ADDENDUM NO. 3

DATE: February 28, 2022
Job No. E180104

METRO EAST SANITARY DISTRICT
Lansdowne Sewer Project

Specifications Dated MAY 2019
(Bids Due Wednesday, **March 9, 2022**, before 10:00 a.m.)
Bid date changed with this Addendum

B. Details (Pages S1 through S4) TRIPLE BOX CULVERT ESCAPE ACCESS MANHOLES

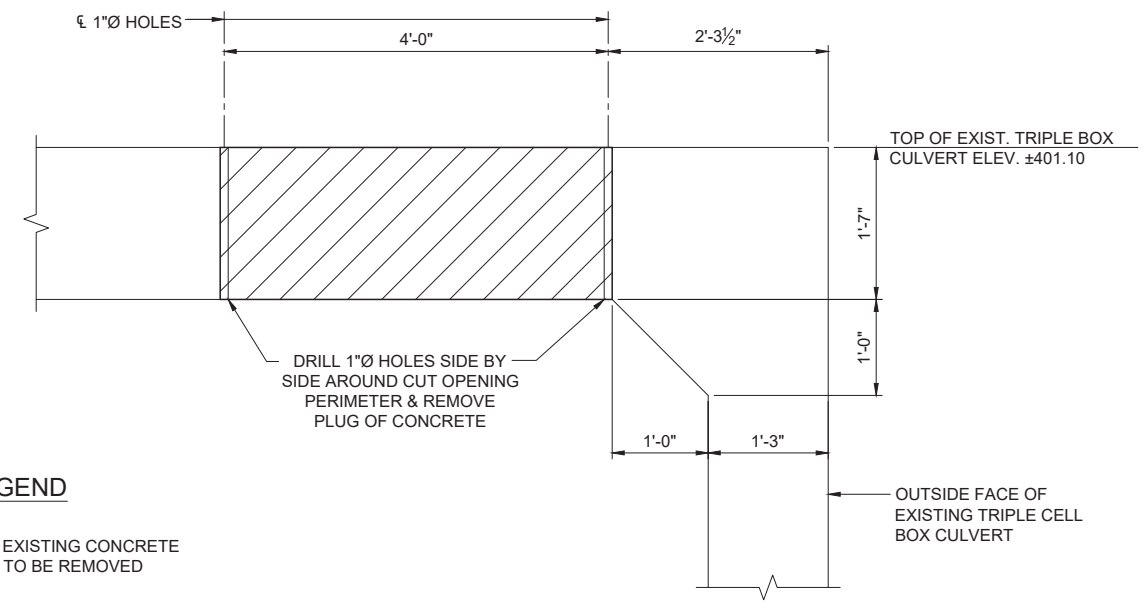
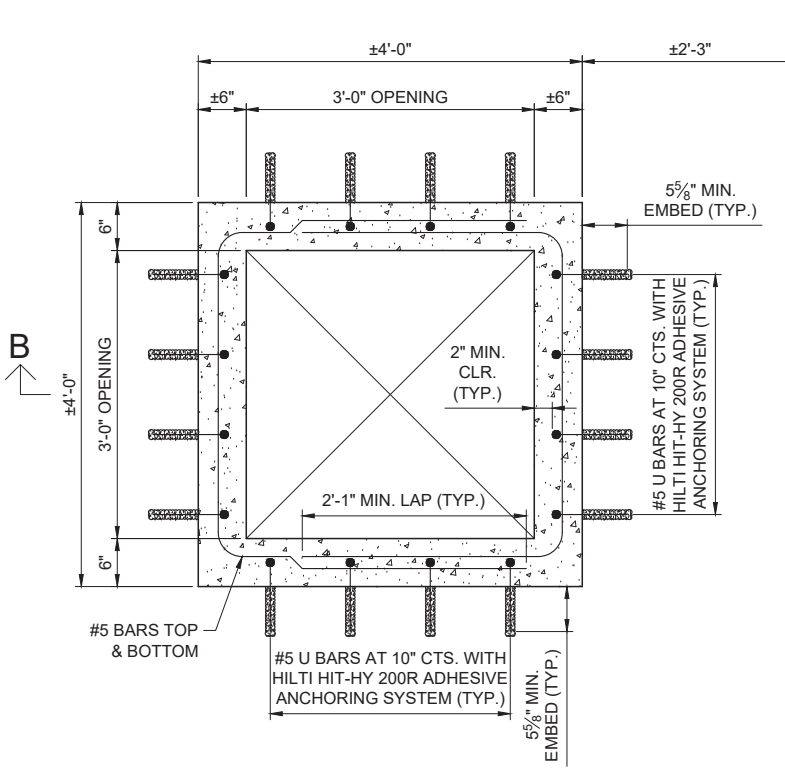
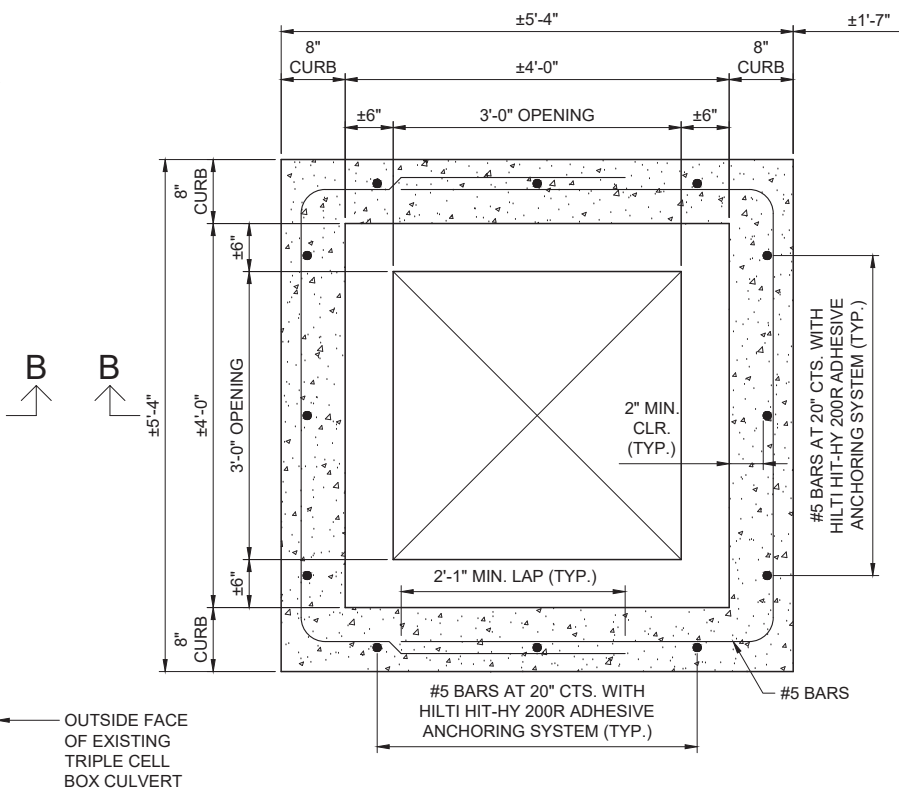
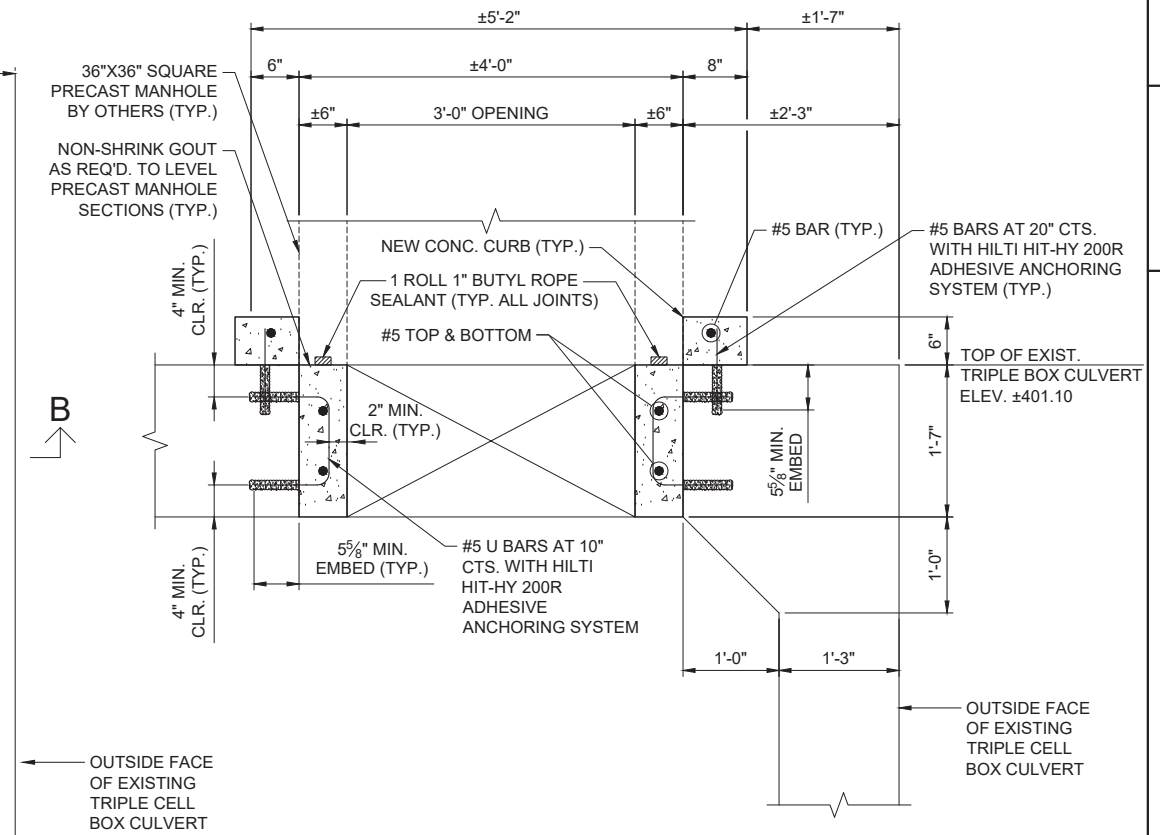
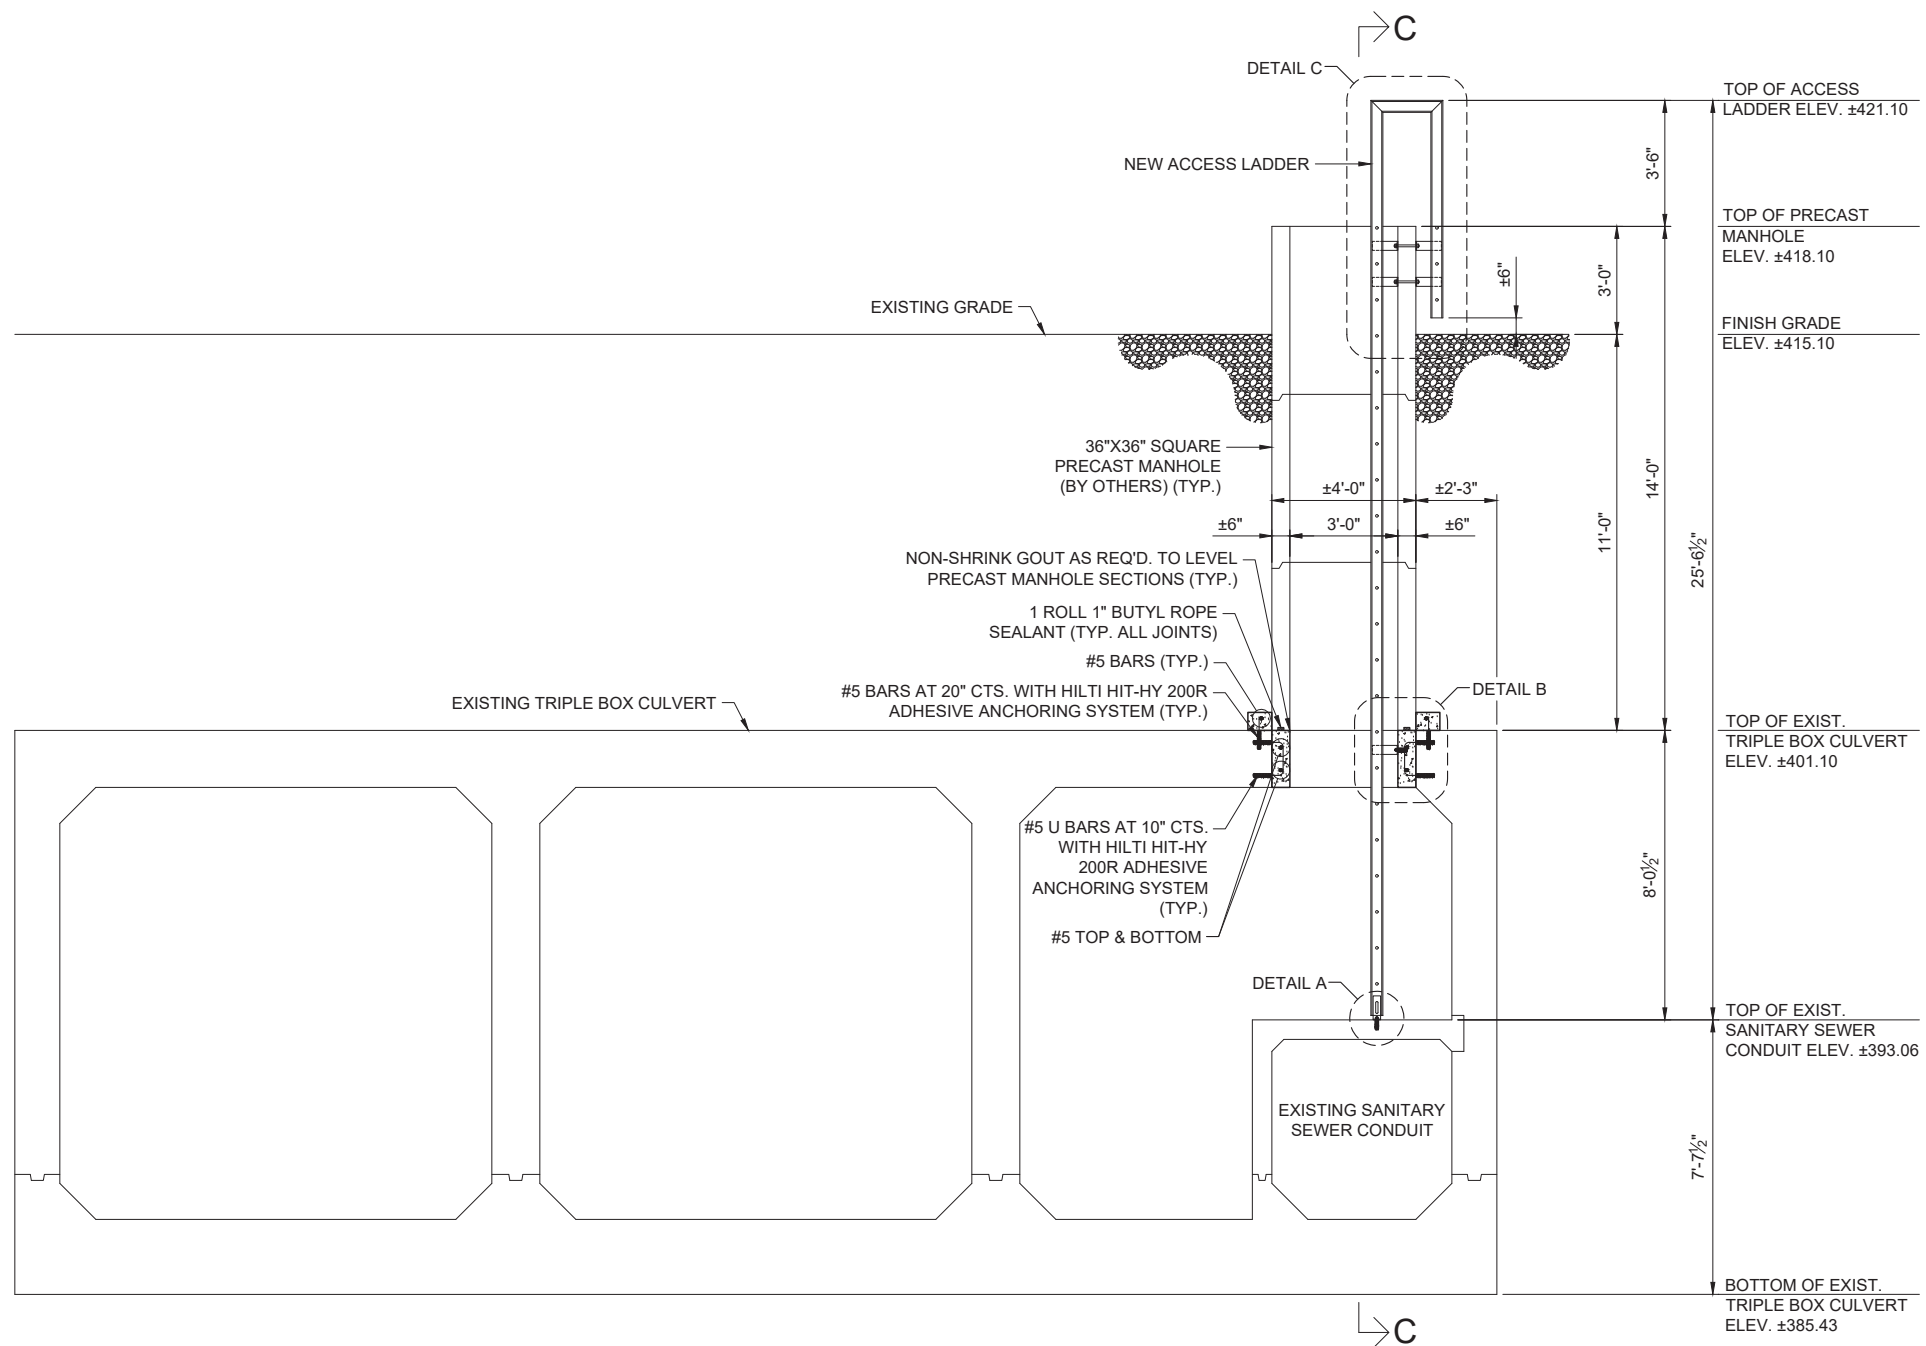
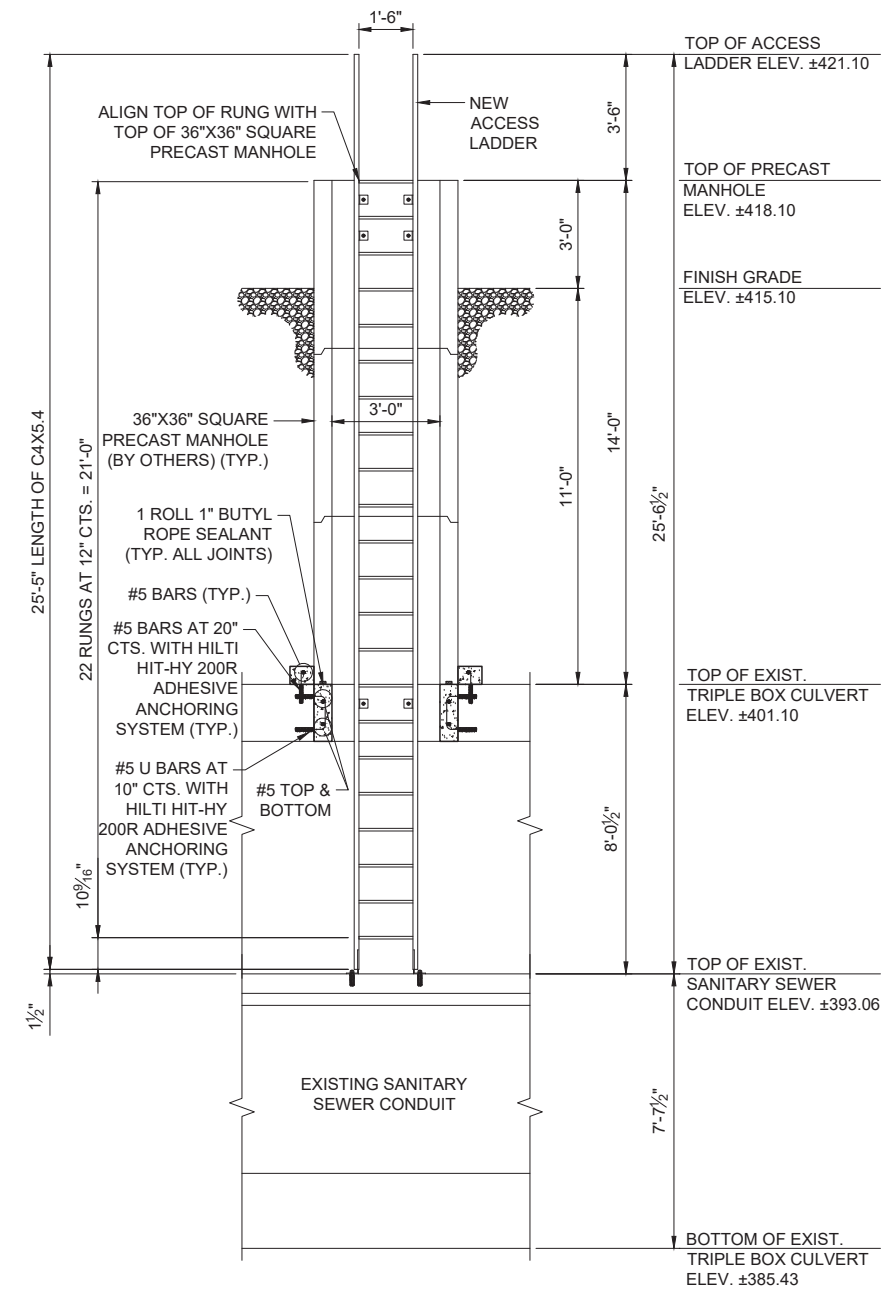
6. Add the following sections/details in reference to Contract Item A-1 (Alternate).

Contract Item A-1
TRIPLE BOX ACCESS MANHOLE

Payment for this contract item shall be at contract unit price per each. The location of the access manholes shall be located on the triple box culvert between manholes 100 and 99. The access manholes shall be constructed approximately 525' upstream of MH 100 and approximately 525' downstream of MH 99. When removing the concrete/rebar for in the top of the existing triple box, contractor shall take care to prevent the concrete from falling and damaging the existing structure. Construction shall include excavation, removal of the existing top, constructing the manhole extension, providing access ladder, and all other items as shown on the detail for complete construction. All joints shall be watertight. Unit price shall include all labor, equipment, and material for complete installation.
